All:  
Attached for Front Office review is the CBP response to RFI 175 (NEPA DOCS).

Thank you for the opportunity to review and comment on the Draft Environmental Assessment and Draft Finding of No Significant Impact for the Proposed Installation of 5.2 Miles of Pedestrian Fence, United States Border Patrol, Tucson Sector, Arizona and adjacent to Organ Pipe Cactus National Monument. Organ Pipe Cactus National Monument staff is submitting the following comments:

Photo 1: Debris backup against the vehicle barrier during one high water flow event at Vulture Wash, Organ Pipe Cactus National Monument, 2005.

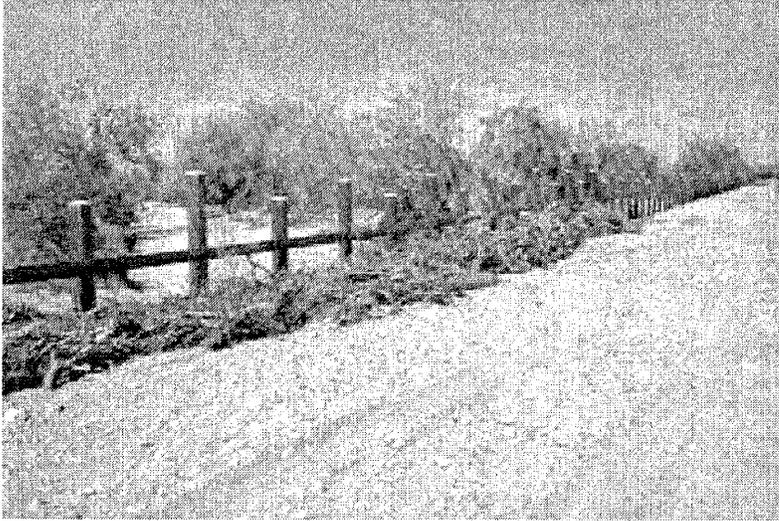
4.9.2, Water Resources, Alternative 2: The National Park Service is concerned about the potential for water to be restricted through washes which the pedestrian barrier will cross. During high water events, debris can build up against any barrier in washes (Photo 1) and change water flow direction and pattern and channel water along the road to an area of less resistance (Photo 2). Any change to water flow direction and pattern will, in turn, change the hydrology of the area on a local and, if large, enough, general scale on both the United States and Mexico side of the international border. The pedestrian fence design should accommodate water flow through the fence without changing hydrologic function of the area.

#	Reviewer	Comment	Response
60	L. Baiza	4.9.2, Water Resources, Alternative 2: The National Park Service is concerned about the potential for water to be restricted through washes which the pedestrian barrier will cross. During high water events, debris can build up against any barrier in washes (Photo 1) and change water flow direction and pattern and channel water along the road to an area of less resistance (Photo 2). Any change to water flow direction and pattern will, in turn, change the hydrology of the area on a local and, if large, enough, general scale on both the United States and Mexico side of the international border. The pedestrian fence design should accommodate water flow through the fence without changing hydrologic function of the area.	A. The design of the fence will allow for the conveyance of water and will not impact the hydrologic function of the area. This is one of the design performance mandates established for the design of the fence. See Section 2.2 of the Final EA.
